ASUS FX506LI/FX506LH/FX706LI N18P-G62/G61 Block Diagram

Model
FX506LT
FX706LT

CHANGE LIST

Quanta Computer Inc.
PROJECT : FX506L/FX706L

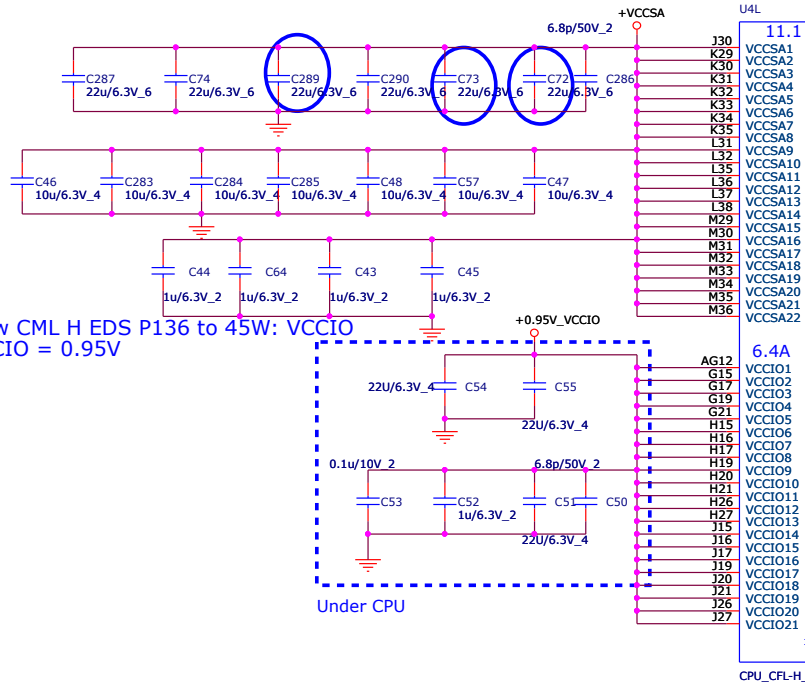
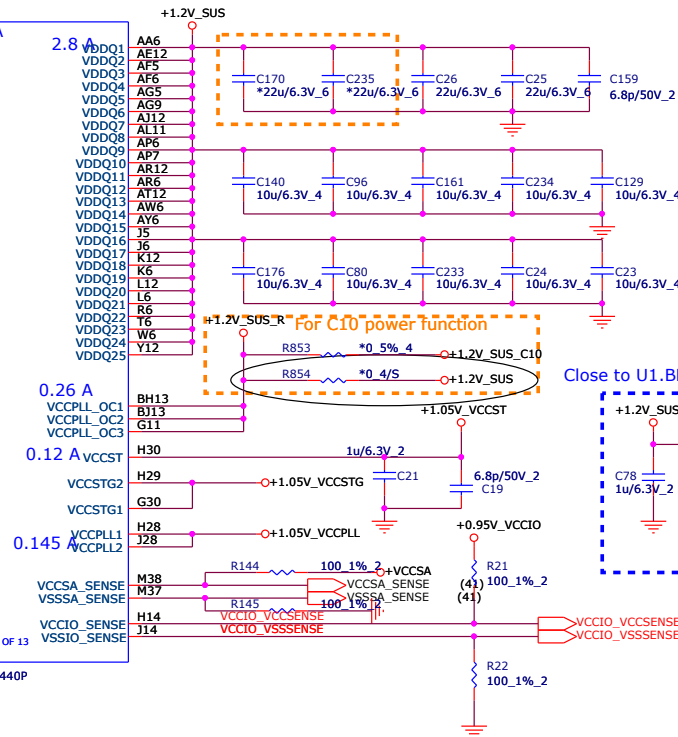
Follow CML H EDS page 135 to 45W(GT2): VCCSA=11.1A
ER-022:Change C289,C73,C72 From 47uF to 22uF for PASS VRTT...1119

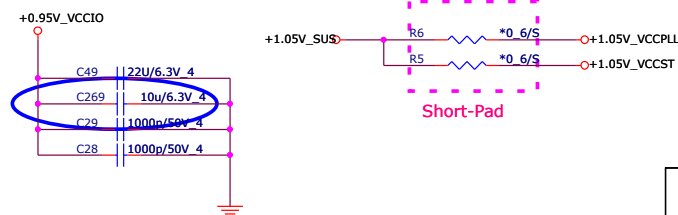
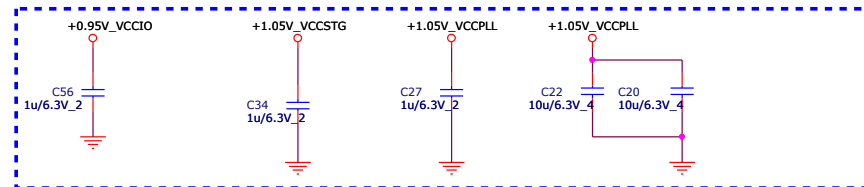
ER-015:Change C269 1000P to 10U_4 for power ripple....1113.

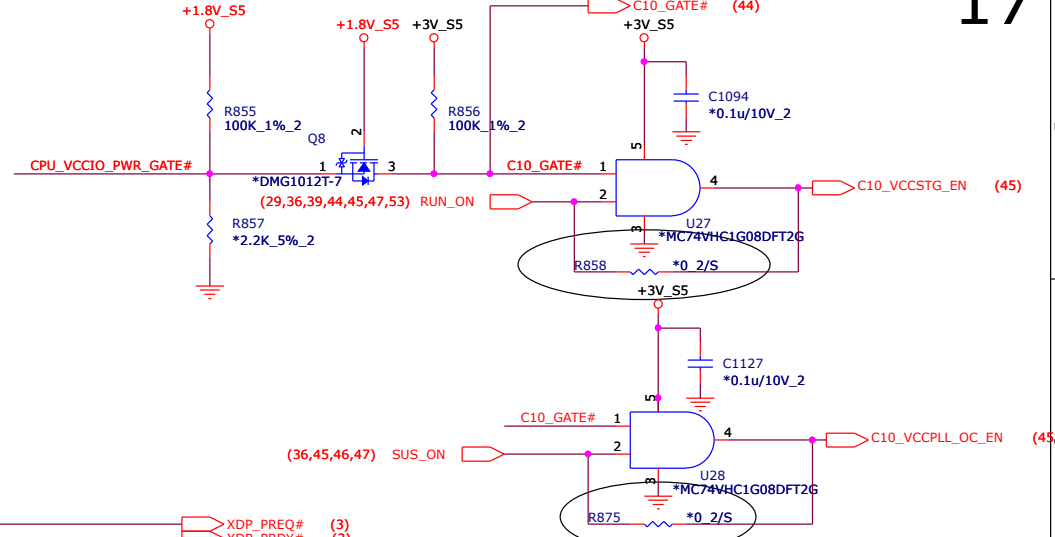
ER-014:Change R858 and C1094,R856 TO NO-MOUNT.....1113.

ER-E35:Reserve U28 for C10 GATE# support.

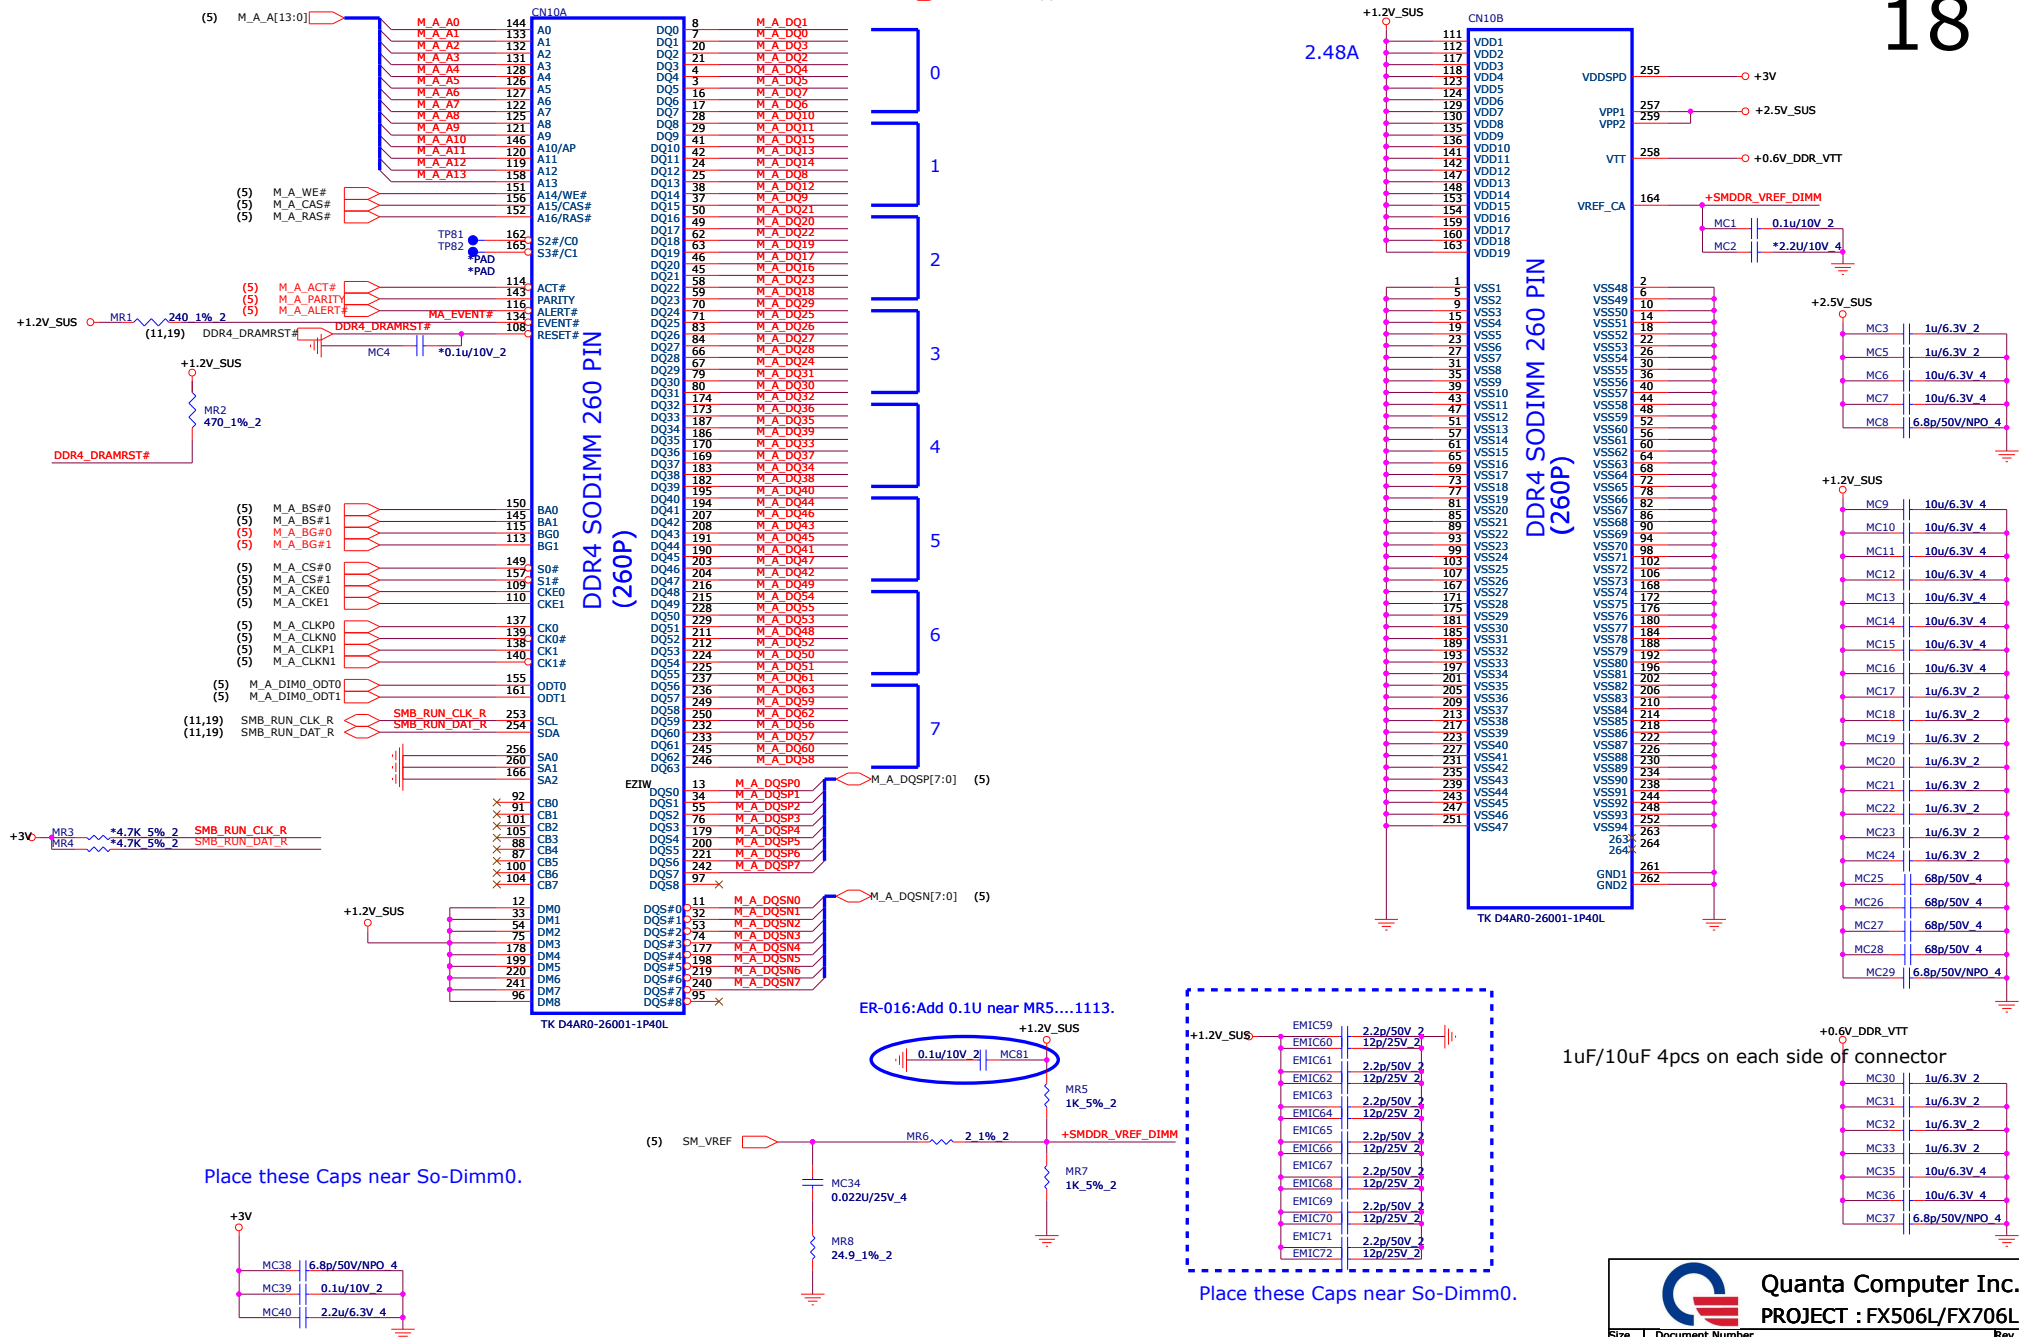
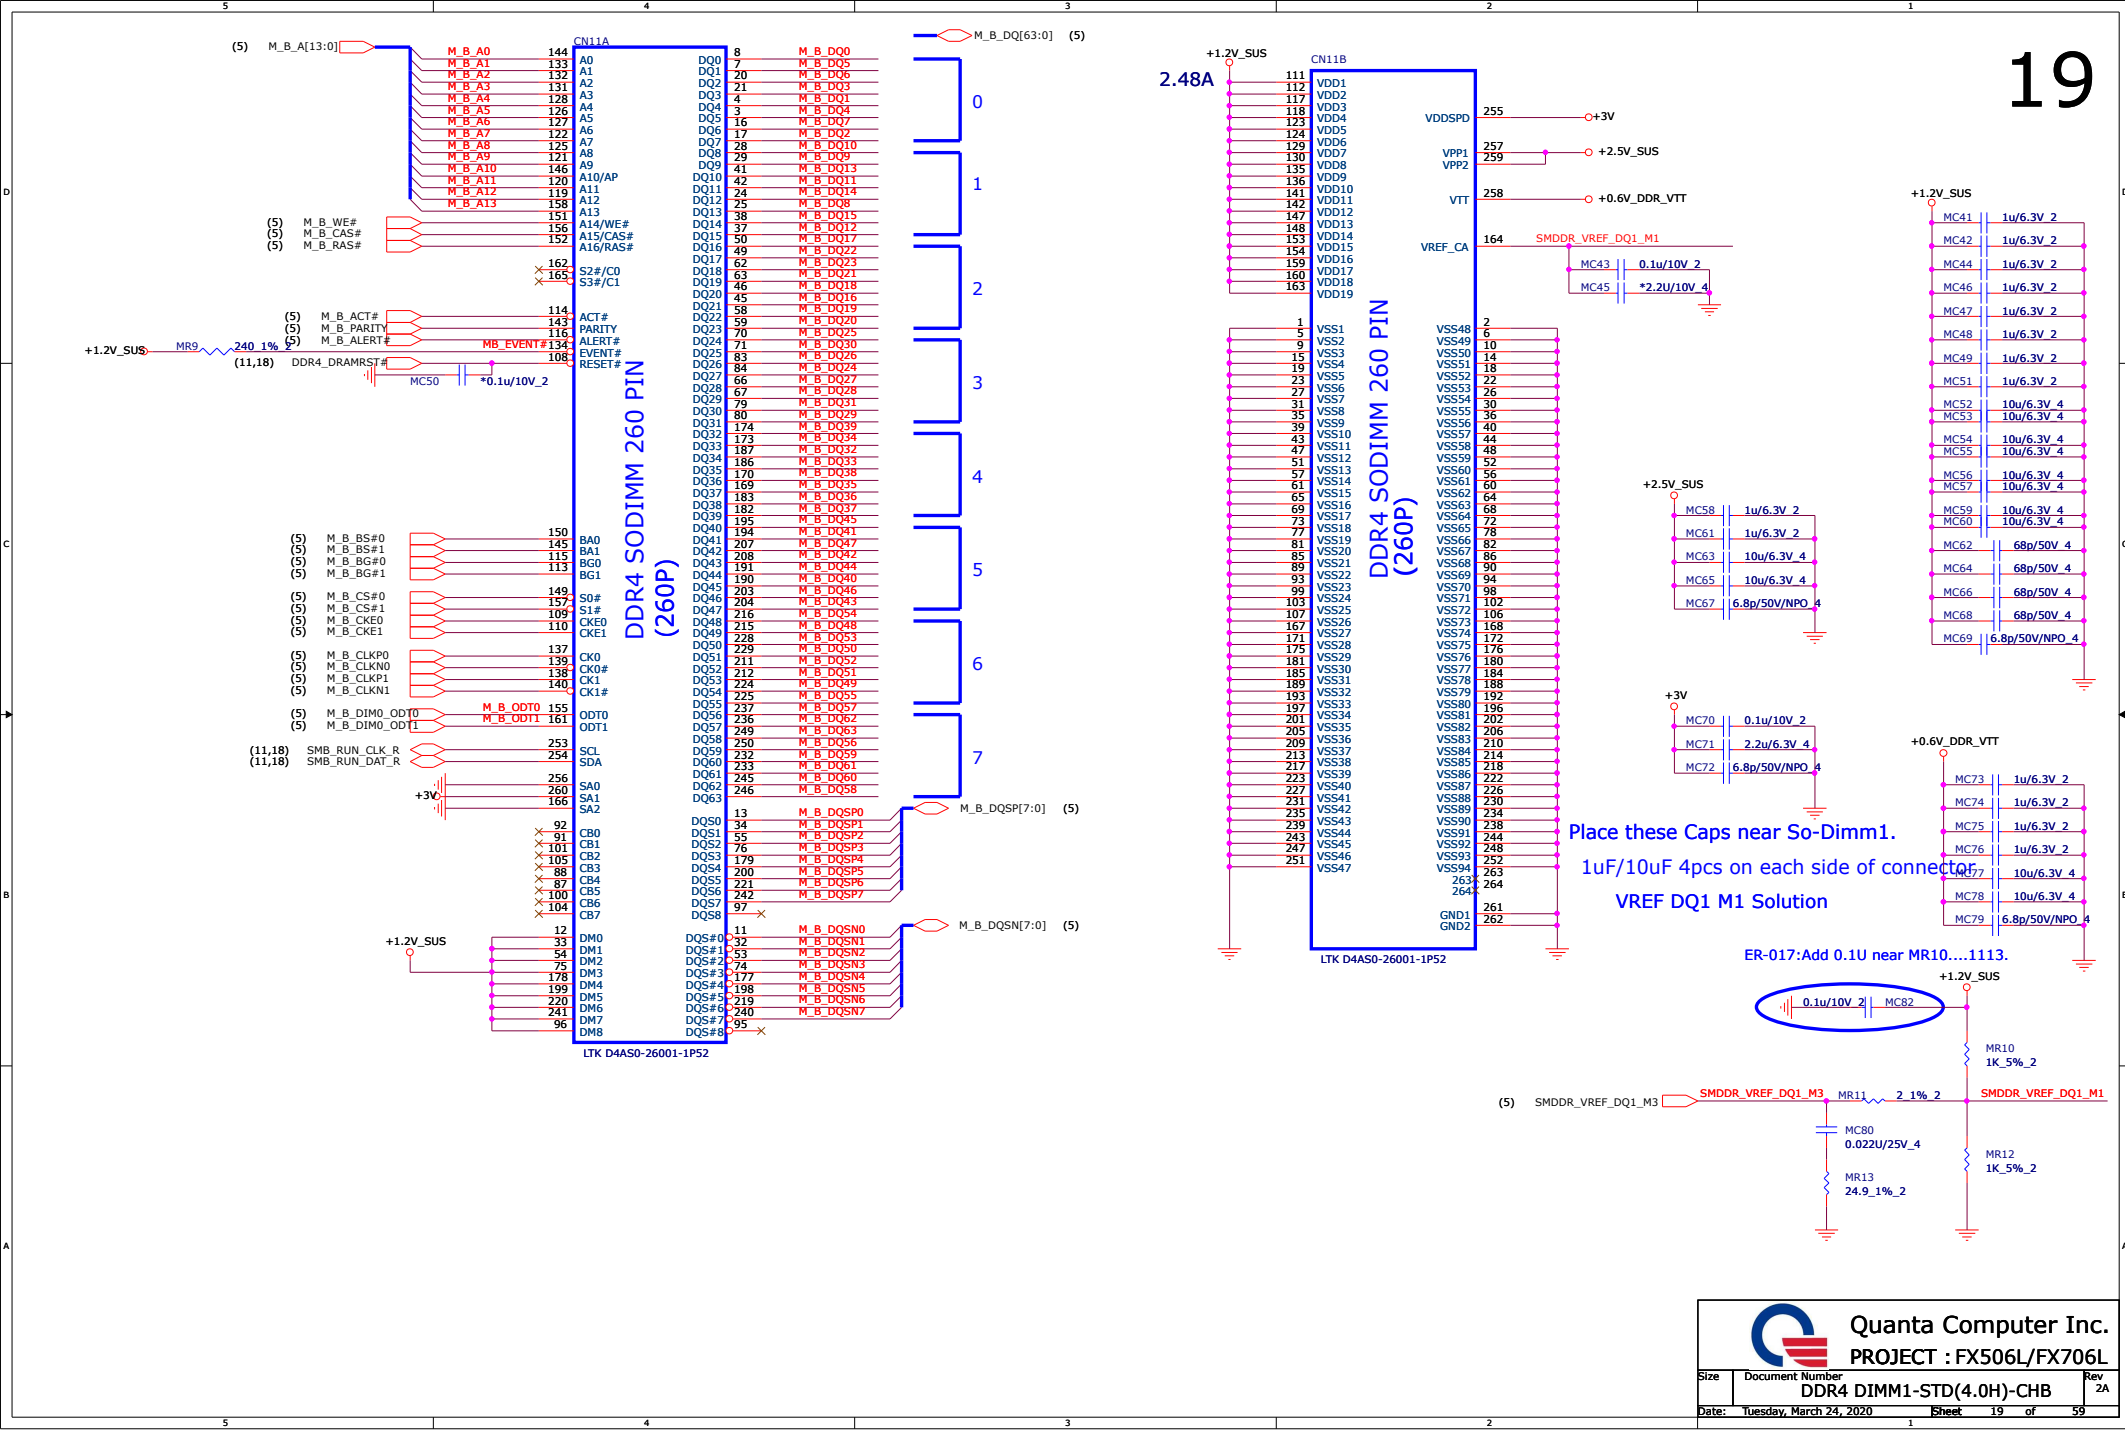
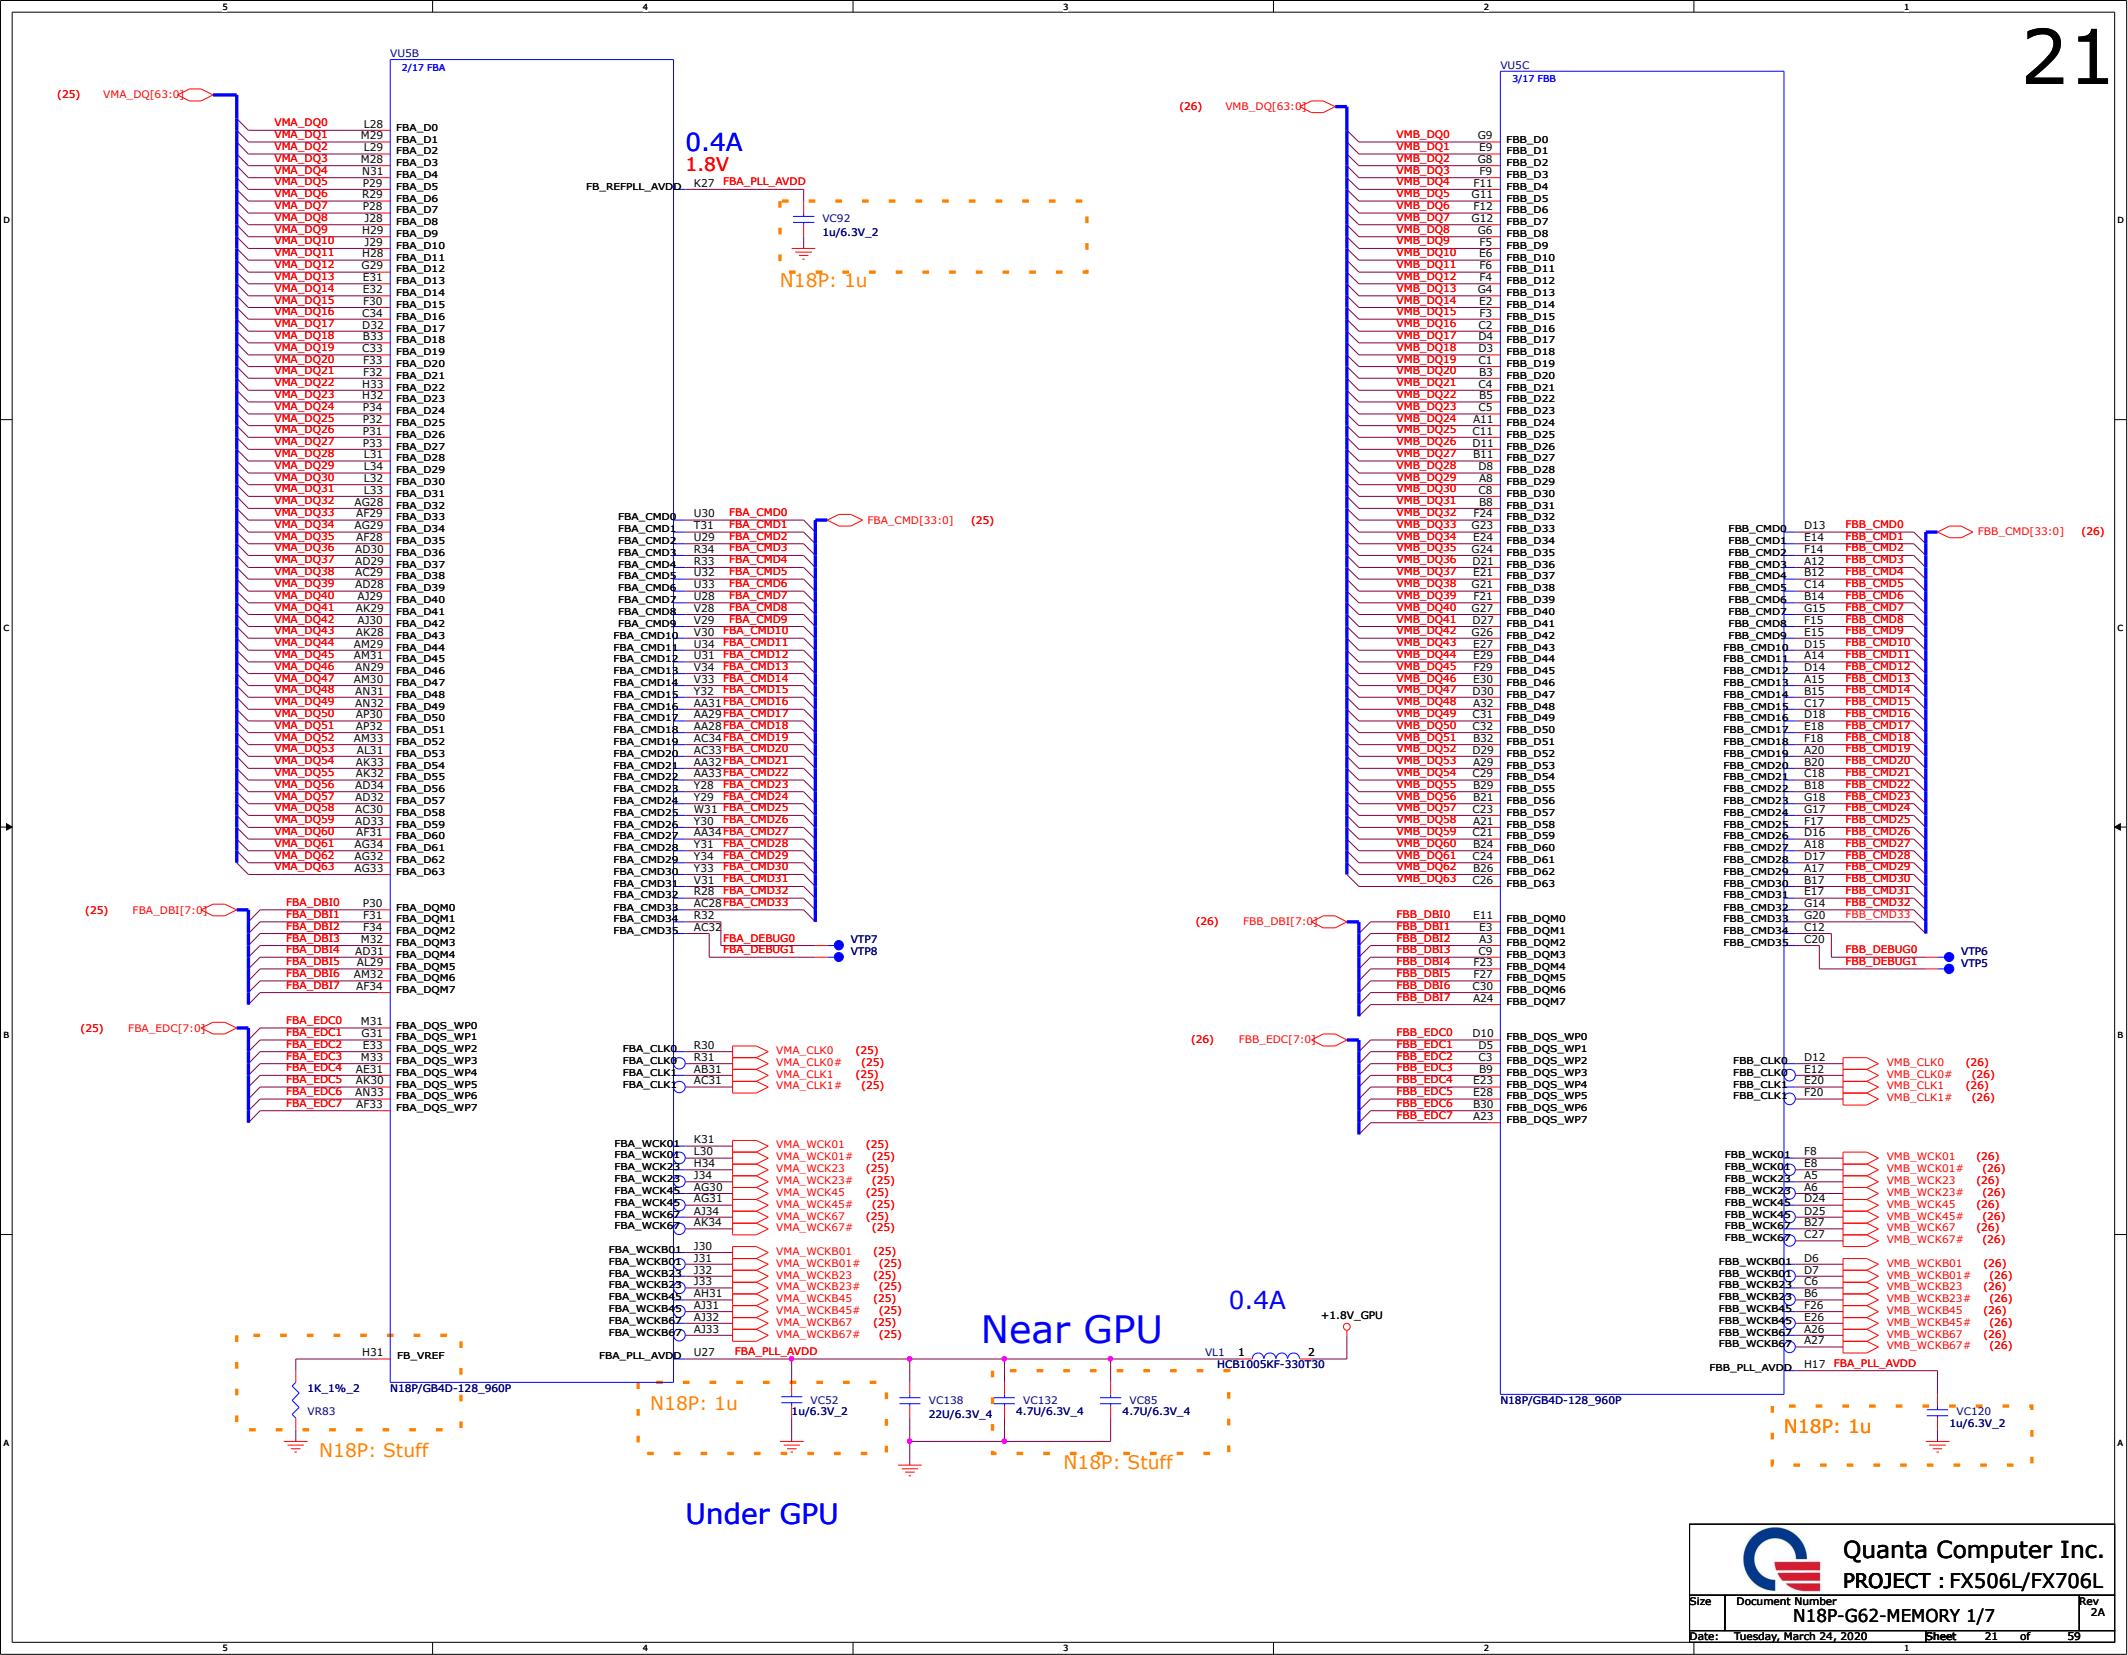
PR-E05:Add EMC89/EMC91/EMC93 0.1uF and EMC90/EMC92/EMC94 for EMI, EMC89 and EMC90 un-mount for Height limitation
PR-E07:EMIC35/EMIC57/EMIC38/EMIC42 change from 100p to 2200p, EMIC37/EMIC47/EMIC40 change from 100p to 0.1u for EMI
placement on TOP SIDE VA+ Plane
